DESIGNED <i>PJO</i>	REVISED - ADDENDUM A 02/20/2013	<b>STATE OF ILLINOIS DEPARTMENT OF TRANSPORTATION</b>	<b>SIDEWALK / SHARED-USE PATH DETAILS NORTH AURORA ROAD</b>		F.A.P. RTE.	SECTION	COUNTY	TOTAL SHEETS	SHEET NO.
DRAWN <i>KES</i>	REVISED -		338	(112 & 113) WRS-7	DUPAGE	1156	354		
CHECKED <i>JCM</i>	REVISED -		SCALE: AS SHOWN   SHEET NO. 29 OF 32 SHEETS   STA. 394+50 TO STA. 398+50			CONTRACT NO. 60R30			
DATE <i>12/14/2012</i>	REVISED -		ILLINOIS FED. AID PROJECT

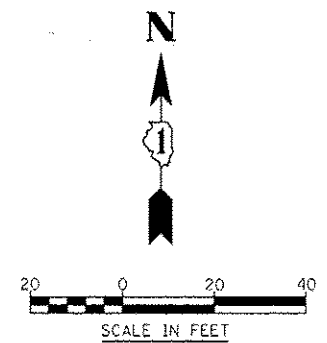
5. FUTURE RETAINING WALL TO BE INCLUDED IN THIS CONTRACT, SEE SHEET 876A FOR ADDITIONAL INFORMATION.
